| Project Title: | Orange Grove Energy Project - Compliance |
| Document Title: | Response to Data Requests 1, 2, and 3 |

**RESPONSE TO DATA REQUESTS 1, 2 AND 3
PETITION FOR POST CERTIFICATION AMENDMENT TO
ADDRESS WATER TRUCK COMPLAINTS
ORANGE GROVE ENERGY, L.P.
DOCKET NO. 08-AFC-4C**

Exhibit 2-1

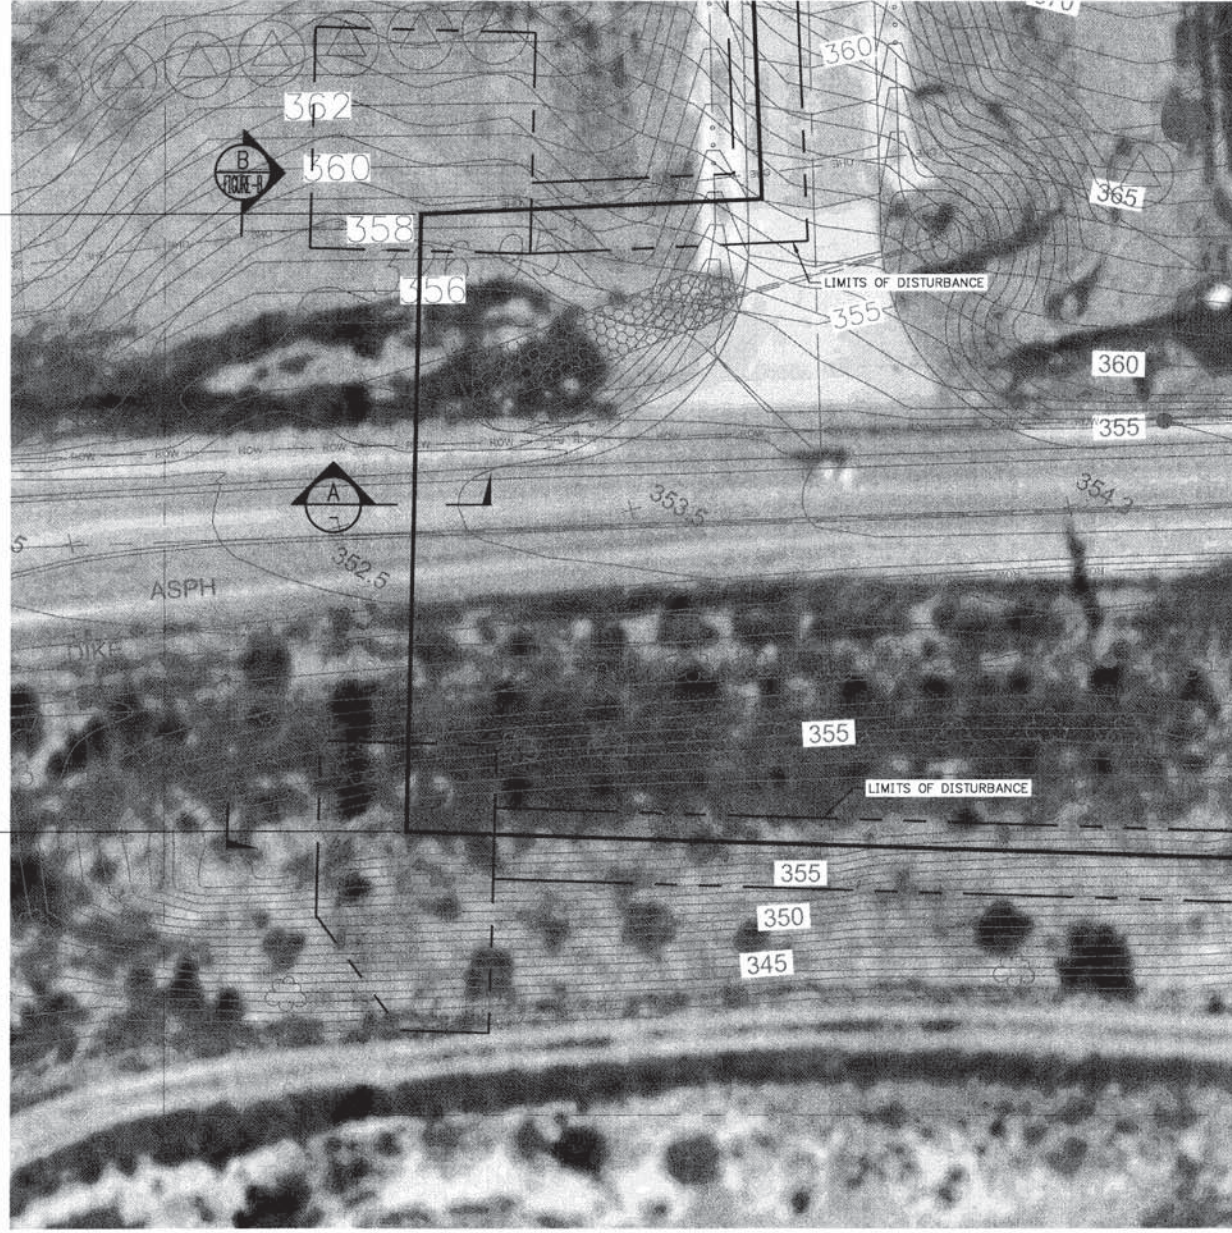
2. Installation of the water supply pipeline is considered a linear underground project and may be subject to requirements of **SOIL&WATER-2**. Please provide the total area of soil disturbance (including, but not limited to, trenching, excavation, staging areas, and stockpile locations) showing how estimates were calculated. If horizontal drilling may be needed to install the pipeline under SR-76, provide the additional areas of disturbance (staging areas, entry pit, and exit pit).

Response to Data Request 2: The table below summarizes the total area of soil disturbance and the basis of the estimate. As shown, the majority of the pipeline would be installed within a construction corridor approximately 16 feet wide. This provides adequate width for soil from trenching to be placed adjacent to the trench until backfilled. Pipe bedding material will be stockpiled on the gravel surfaced area within the OGEC property. Minor soil stockpiling from entry and exit points at HDD work (Exhibit 2-3) would occur within the disturbances for those areas.

| LOCATION/ACTIVITY | DISTURBED AREA | BASIS OF AREA ESTIMATE |
|---|----------------|---|
| Trenching, pipeline installation, and backfilling between the OGEC secondary access road and the HDD boring site. | 960 sq ft | 60 linear feet with maximum soil disturbance width of 16 feet. Area shown in Exhibits 2-1 and 2-2. |
| Boring, pipeline installation and backfilling at the HDD boring site on north side of SR-76 | 2,500 sq ft | 50 x 50 foot square area shown in Exhibits 2-1 and 2-2. |
| Boring, pipeline installation and backfilling at the HDD receiving site on the south side of SR-76 | 2,200 sq ft | 40 x 60 foot polygon area shown in Exhibits 2-1 and 2-2. |
| Trenching, pipeline installation, and backfilling between HDD receiving site and wellhead | 14,400 sq ft | 900 linear feet with maximum soil disturbance width of 16 feet. Area shown in Exhibit 2-1. Two short 4-inch diameter HDD segments will avoid surface disturbance within 20 feet of drainages. |
| Wellhead Work and Wellhead Staging Area | 7,700 sq ft | Area shown in Exhibit 2-1. |
